SUBJECT: **Optional Product Improvement Program 22G07 - Supplement #1**
 Certain 2020-2022 Model Year Police Interceptor Utility Vehicles Equipped with a Low Band Frequency Noise Suppression Kit - Electromagnetic Compatibility Upgrade

REF: **Optional Product Improvement Program 22G07**
 Dated: June 15, 2023

New! REASON FOR THIS SUPPLEMENT

FIGURE 11

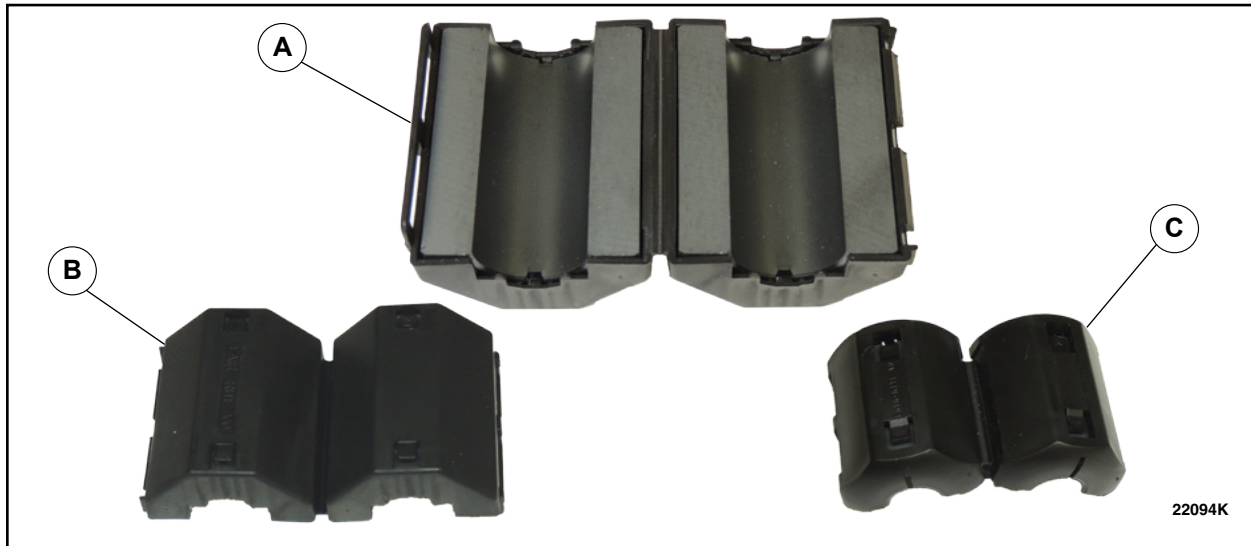
Technical Information: Ferrite table quantities and one ferrite type was updated from medium to large in one location.

NOTE: The Quantities for items A and B have been updated. See table below.

Item	Description	Non- Ford Part Number	Quantity
A	Large Hex Ferrite	0444177081	4
B	Medium Hex Ferrite	0444176451	3
C	Small Hex Ferrite	0444164181	1

FIGURE 15

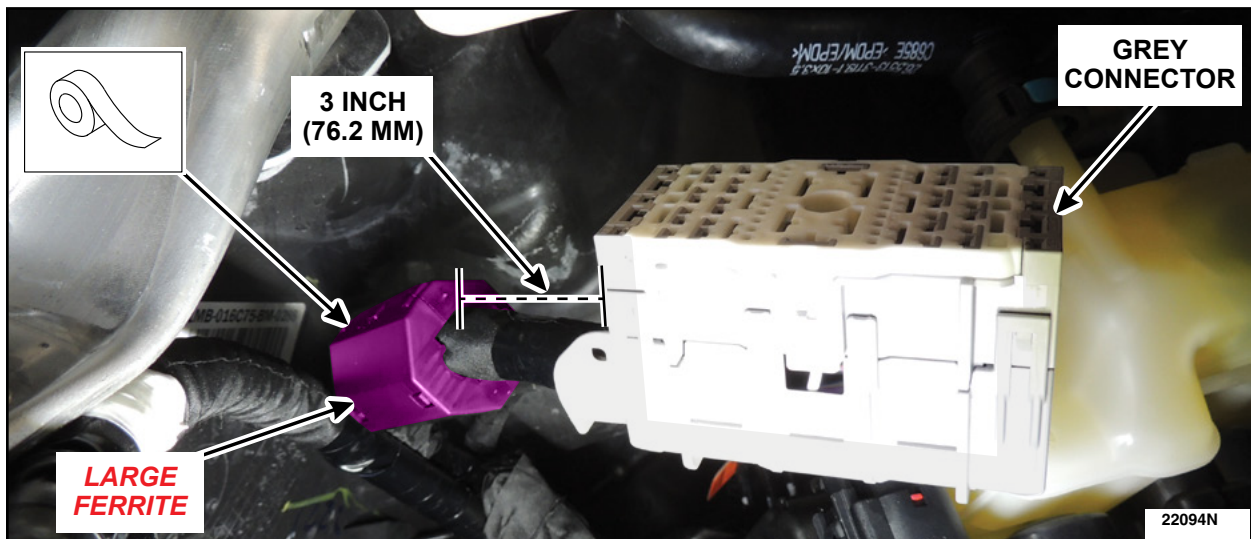
NOTE: Ferrite type was updated for the gray connector wire to allow a better fit.

21. Measure 3 inches (76.2 MM) from the back of the grey connector. Install a **LARGE** ferrite (item A) to the wiring harness in the designated location. See Figure 15. Apply 3 wraps of Coroplast® tape around the ferrite to secure it closed *and any additional tape to prevent movement on the harness.*
